SIB 61 01 24

2024-07-10

RATTLING NOISE ORIGINATING FROM WINDSHIELD WASHER FLUID RESERVOIR

This Service Information Bulletin (Revision 2) replaces SI B61 01 24 **dated February 2024**.

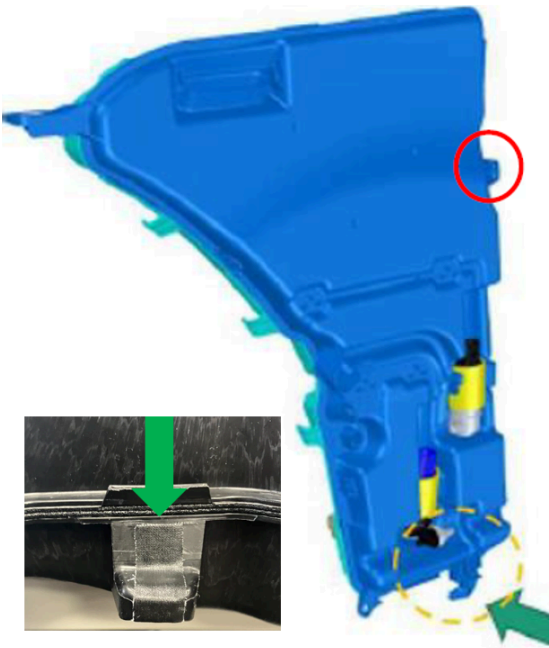
The washer fluid reservoir mounting hook has too much play, which allows the reservoir to vibrate and cause a noise.

Replace the washer fluid reservoir.

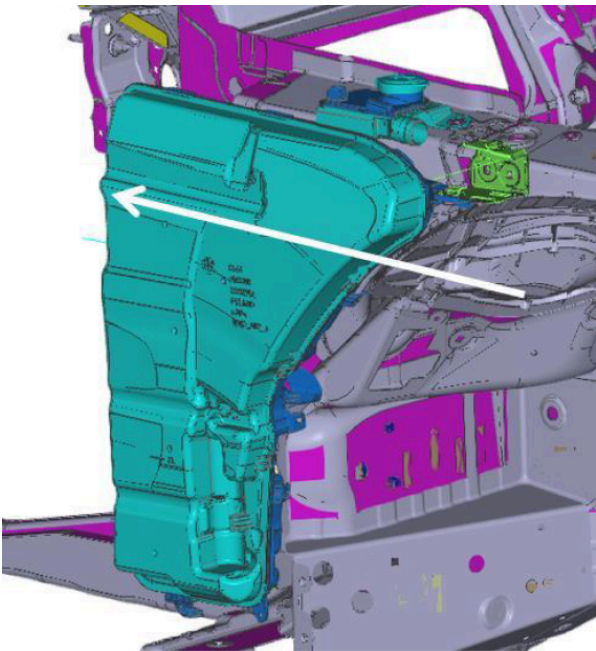
4. Before installing the new reservoir, apply two pieces of fabric tape to the upper mounting point (circled in red).

Note: layer fabric tape one piece on top of the other.

5. After guiding the washer fluid reservoir into the holder. Press the reservoir firmly towards the passenger compartment before tightening the self-locking hex bolt.
